METROPOLITAN GOVERNMENT OF NASHVILLE AND DAVIDSON COUNTY

STAFF RECOMMENDATION 1103 McKennie Avenue May 17, 2017

Application: New construction—addition and DADU; Setback determination

Description of Project: Application is to construct a rear addition and a detached accessory dwelling unit (DADU). The addition requires a side setback determination. Base zoning requires a five foot (5') side setback, and the applicant is proposing an addition that is approximately three feet, six inches (3'6") from the side property line. The addition also involved enclosing a side porch and enlarging a door opening.

Figure 1. 1103 McFerrin

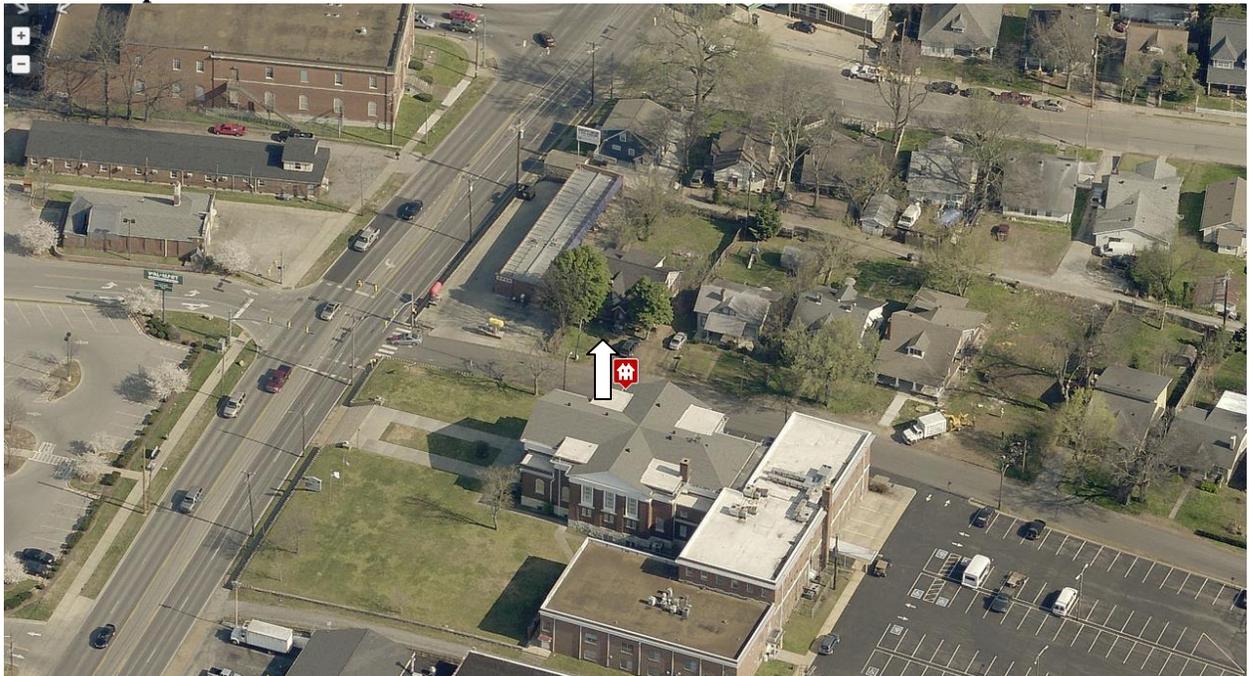
Background: 1103 McKennie is a c. 1930 Tudor Revival style brick house that contributes to the historic character of the Eastwood Neighborhood Conservation Zoning Overlay (Figure 1).

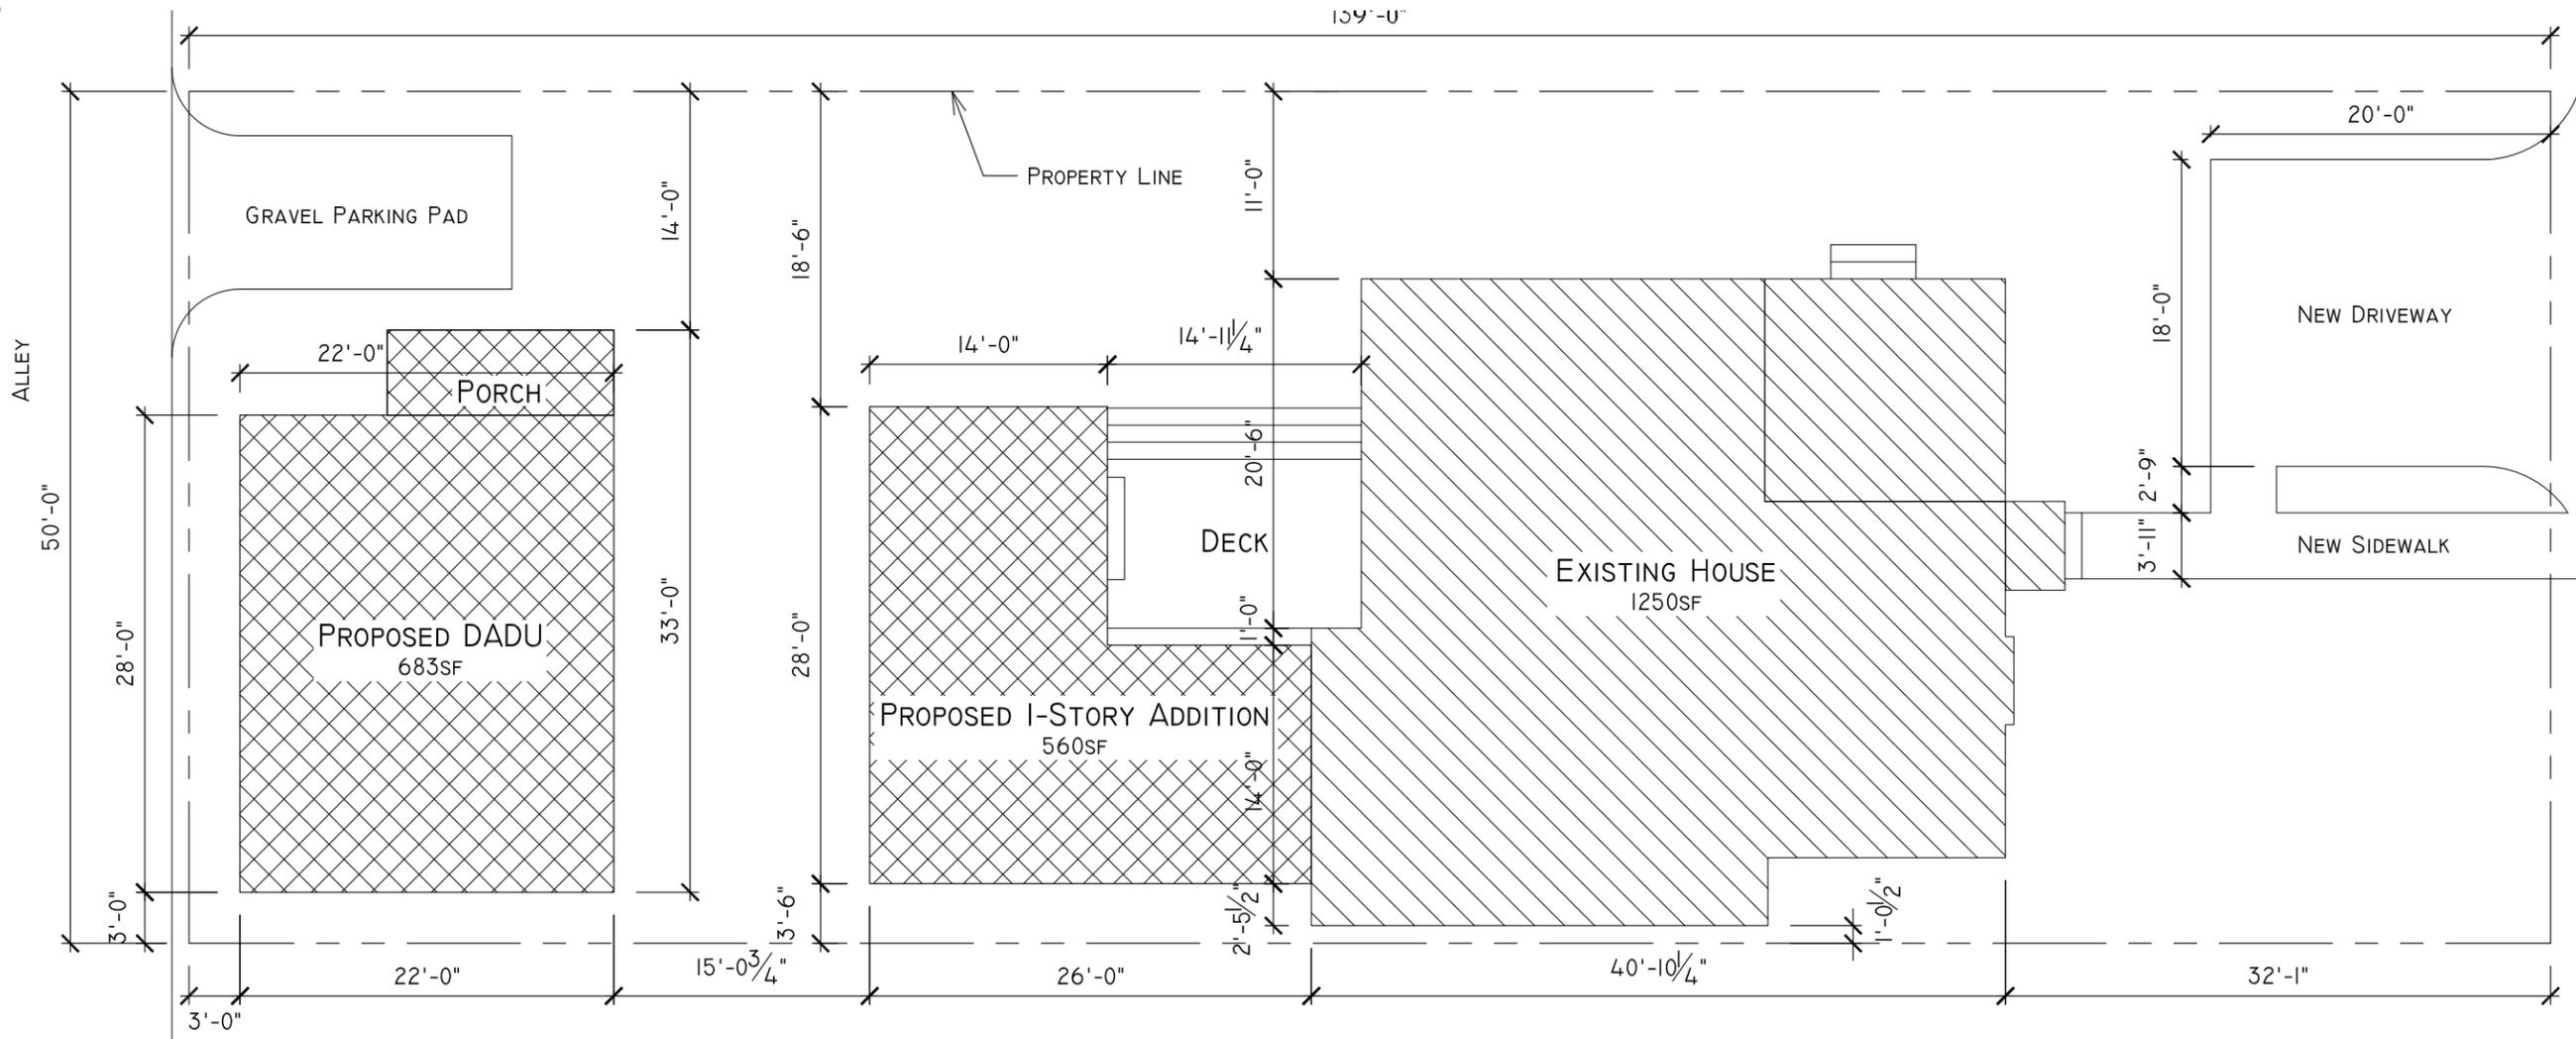
Existing conditions (height of historic portion of the home to be measured from finished floor)	Potential maximums (heights to be measured from grade)	Proposed (should be the same or less than the lesser number to the left)
Ridge Height	24'	25'	21'7"
Eave Height	11'	10'	9'

Lot is less than 10,000 square feet	50% of first floor area of principle structure	Proposed footprint
Maximum Square Footage	750 sq. ft.	905 sq. ft.	683 sq. ft.

Staff finds that the DADU meets section II.B.h.1 of the design guidelines and 17.16.30.G. 7 of the ordinance.

SITE PLAN

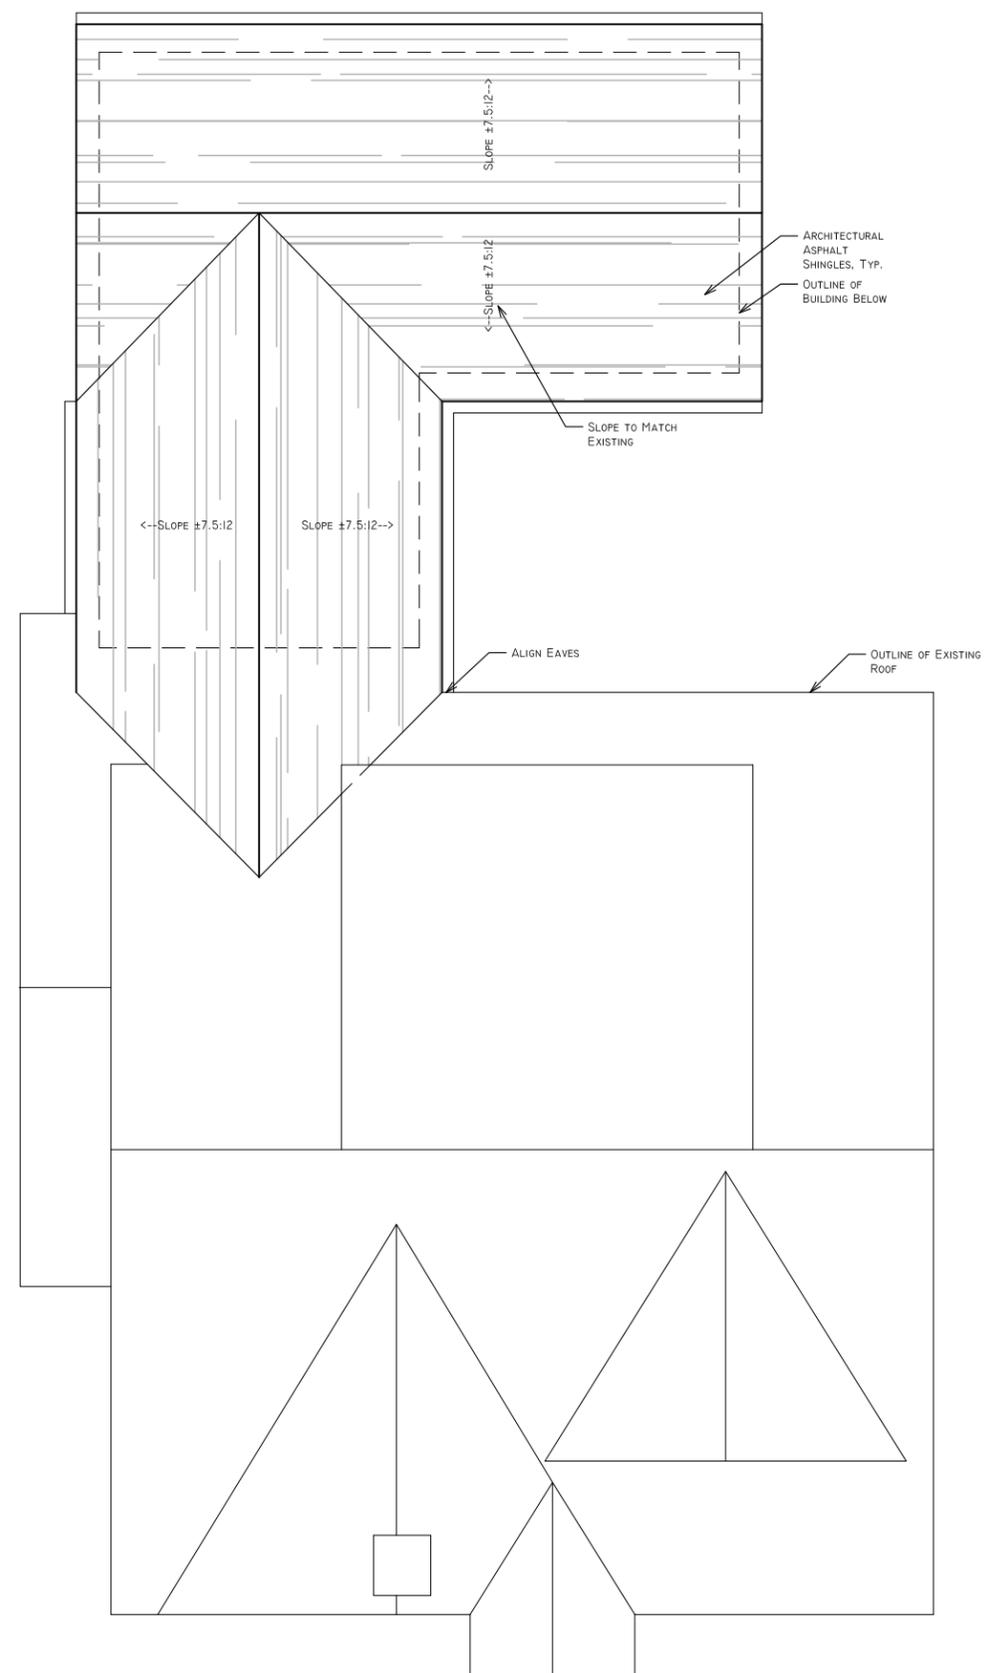
Setback & Rhythm of Spacing: The proposed addition meets the base zoning setbacks on the rear and right sides. It is approximately forty feet (40') from the rear property line and eighteen feet, six inches (18'6") from the right side property line. The addition does require a setback determination on the left side. Base zoning requires that additions be a minimum of five feet (5') from the side property line. However, the applicant is proposing to situate the addition three feet, six inches (3'6") from the side property line.

Staff finds that the proposed setback determination meets the design guidelines for several reasons. The existing historic house does not meet the required five foot (5') side setback. It is situated about one foot (1') from the side property line (Figure 4). The addition will be inset two feet, six inches (2'6") from the back corner of the house, so the addition will not encroach on the side setback any more than the existing house. The addition is also modestly scaled at twenty-six feet (26') deep. Moreover, the left side property line abuts the rear property line of a commercial property that is currently being used as car wash (Figure 5). The reduced side setback will not affect any current residences. Staff finds that the addition meets Sections II.B.1.c. and II.B.2. of the design guidelines.

*MHZC typically recommends a minimum of twenty feet (20') in between the back of the house/addition and the outbuilding. The applicant is proposing just fifteen feet, one inch (15'1") in between the back of the addition and the outbuilding. Staff finds the reduced space to be appropriate in this instance because the lot is unusually shallow. In fact, it is the shallowest lot on the block. It is less than one hundred and forty feet (140') deep, whereas other lots on this block are between one hundred and fifty and one hundred and seventy feet (150'-170') deep.

FIRST FLOOR PLAN
02

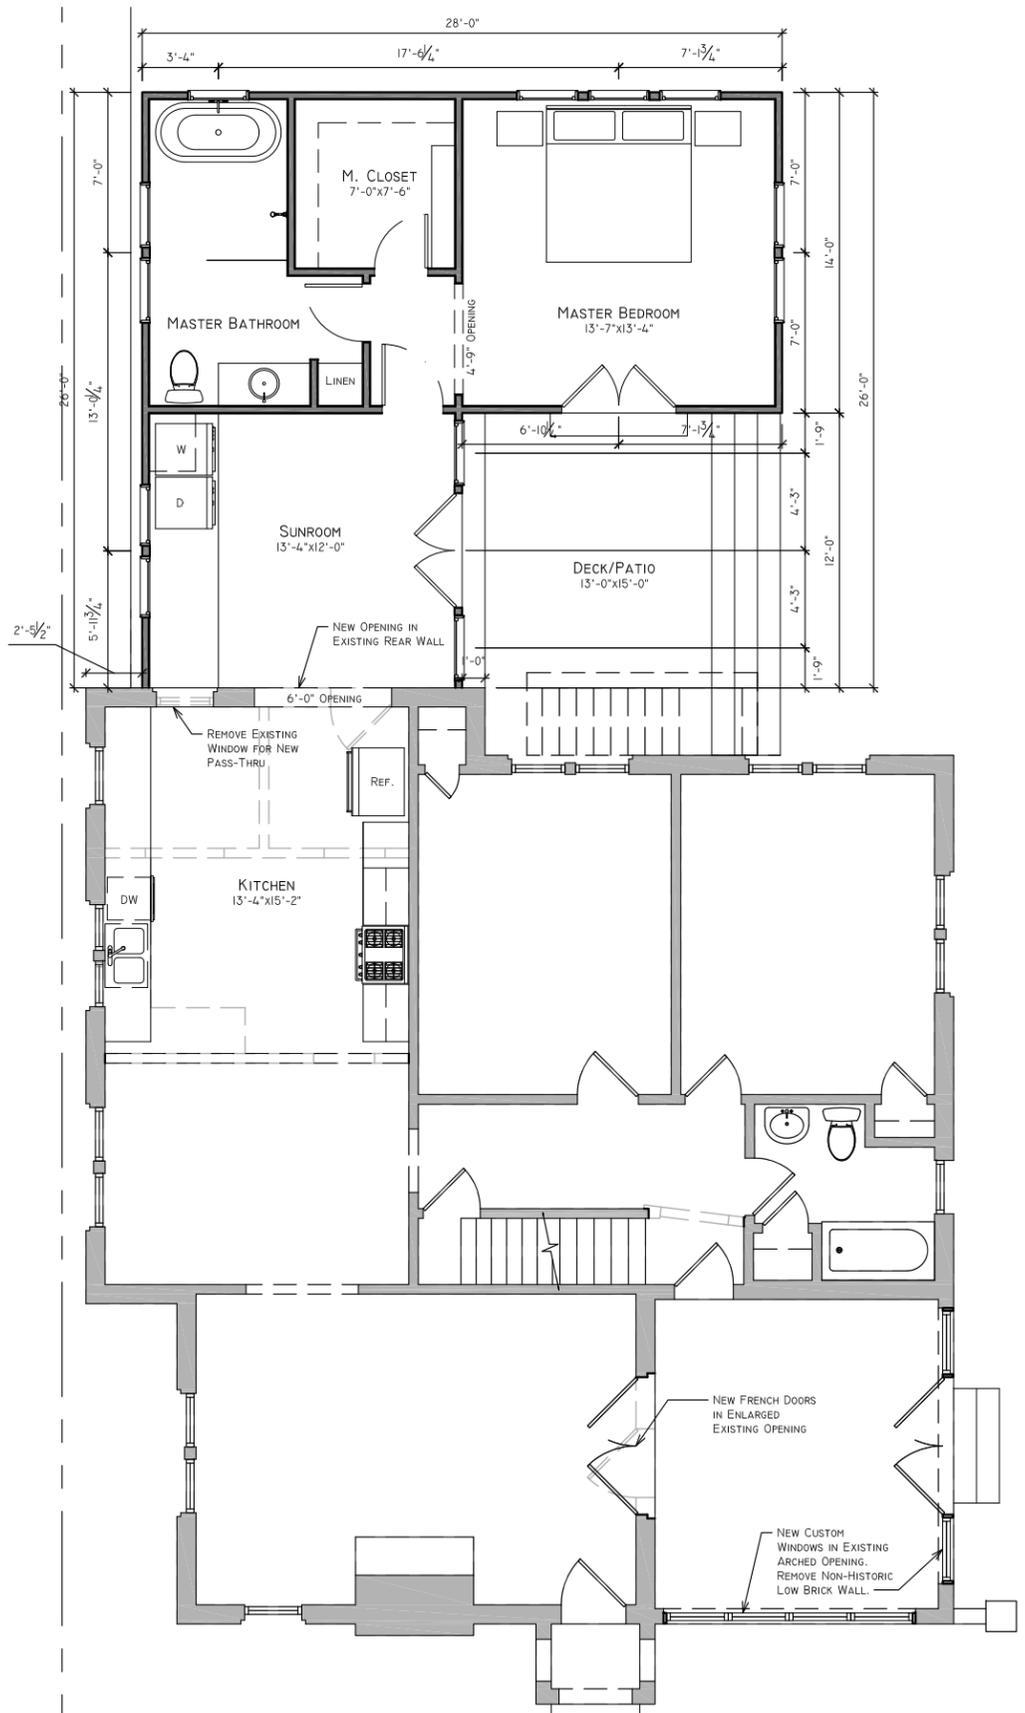
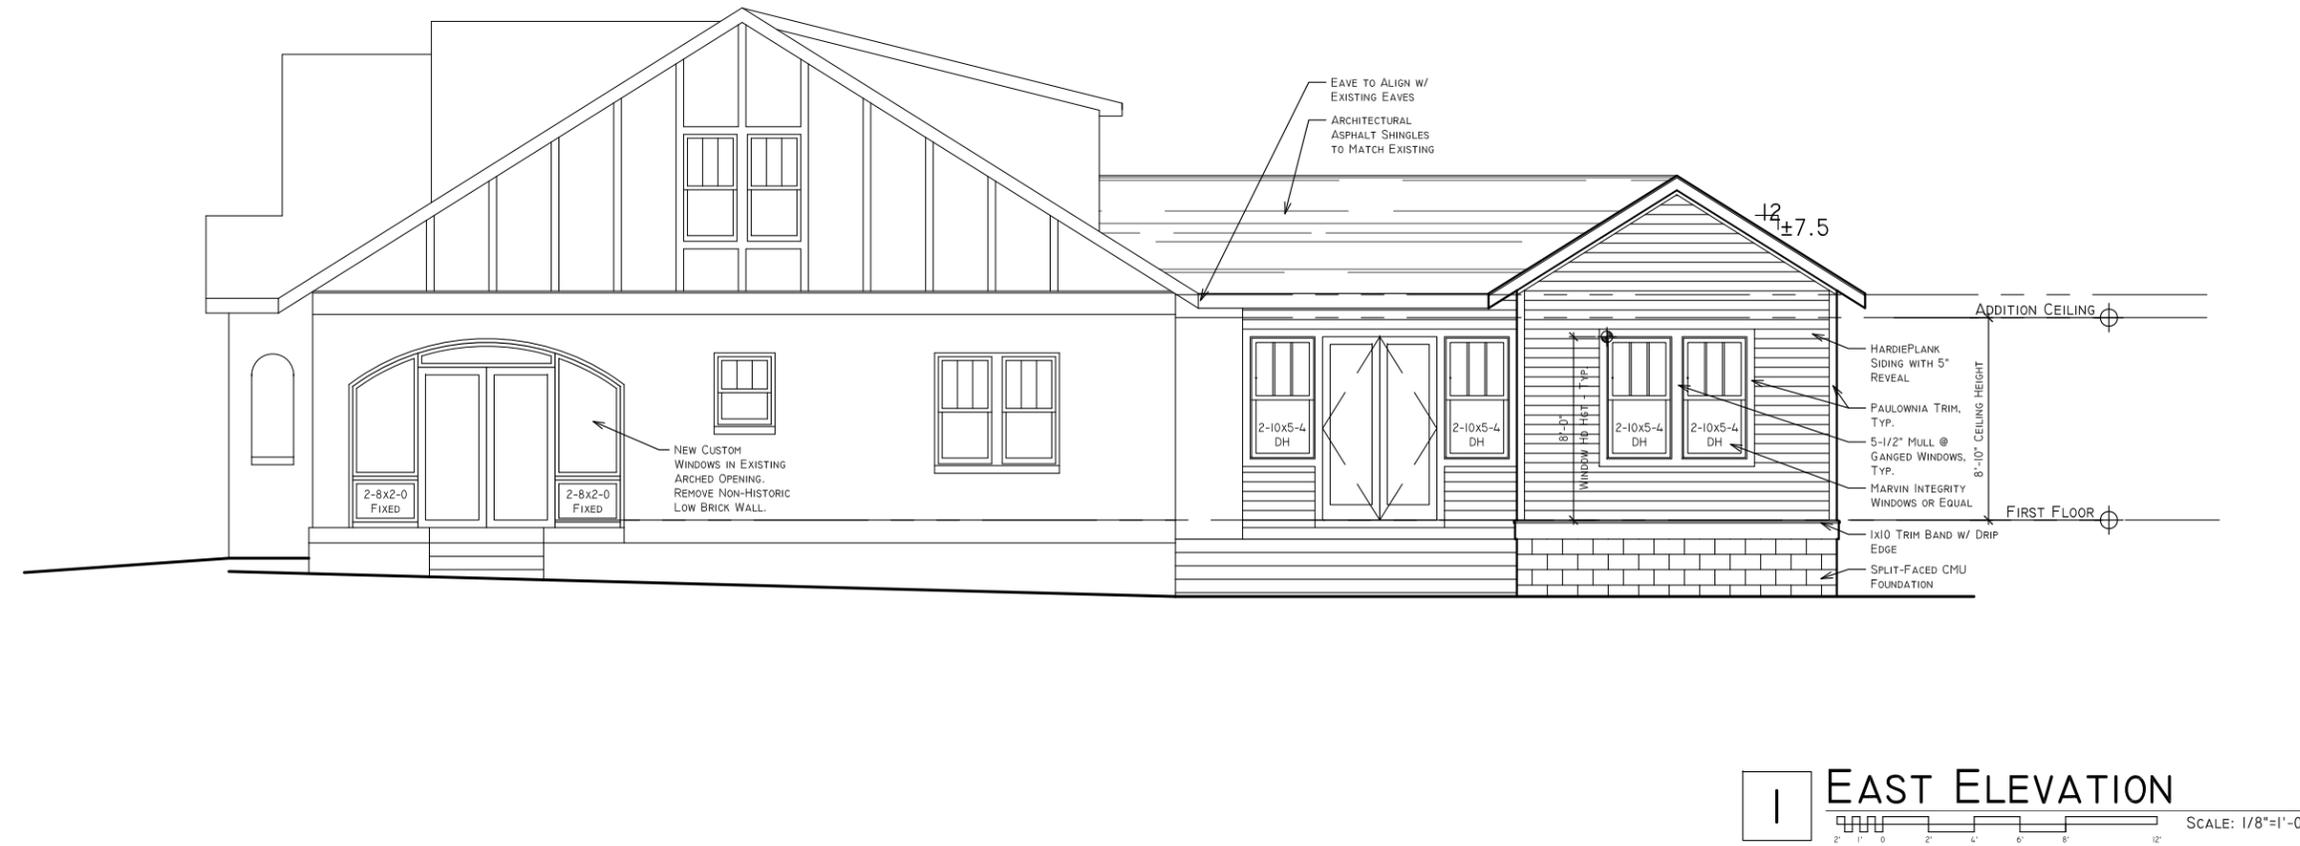
The applicant also plans to enlarge the existing single door, to the left side on the porch, behind the side porch (see Figures 2 & 3). The single door will become a double door opening. Staff finds that this enlargement is appropriate for a couple of reasons. Although possibly original, the door opening is not a significant part of the historic house's architecture. Once the side porch is enclosed, as is proposed, the door opening will only be minimally visible from the street. Staff therefore finds that the partial demolition of enlarging the side door meets Section III.B.2 for appropriate demolition and does not meet section III.B.1 for inappropriate demolition.

The addition is inset two feet (2'6") from the left side of the house and is inset over twenty feet (20') from the right side of the addition. The addition will have a depth of twenty-six feet (26') and a width of twenty-eight feet (28'). Overall, the addition will add five hundred and sixty square feet (560 sq. ft.) to the historic house, which has a footprint of one thousand, two hundred, and fifty square feet (1,250 sq. ft.). Staff finds that the addition's height and scale meet Sections II.B.1.a., II.B.1.b., and II.B.2. of the design guidelines.

Appurtenances & Utilities: No changes to the site’s appurtenances were indicated on the drawings. The applicant intends to retain the parking area in the front of the house. The location of the HVAC and other utilities was not noted. Staff asks that the HVAC be located on the rear façade, or on a side façade beyond the midpoint of the house.

1. The brick railing on the side porch remain;
2. Staff approve the windows for the side porch enclosure;
3. Staff approve all new doors;
4. Staff approve the material of the parking areas;
5. The HVAC shall be located behind the house or on either side, beyond the mid-point of the house; and
6. Staff receive a copy of the filed restrictive covenant for the DADU.

DADU FLOOR
 PLAN
05

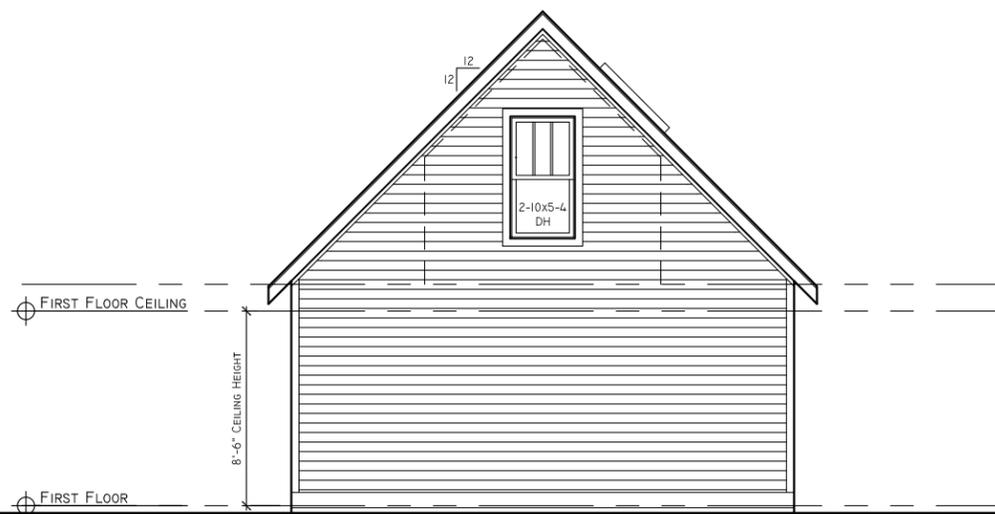
MINIMUM	PROPOSED
Space between principal building and DADU/Garage	20'	15'1" *
Rear setback	3'	3'
L side setback**	3'	3'
R side setback**	3'	14'
How is the building accessed?	From the alley or existing curb cut	No vehicle door.
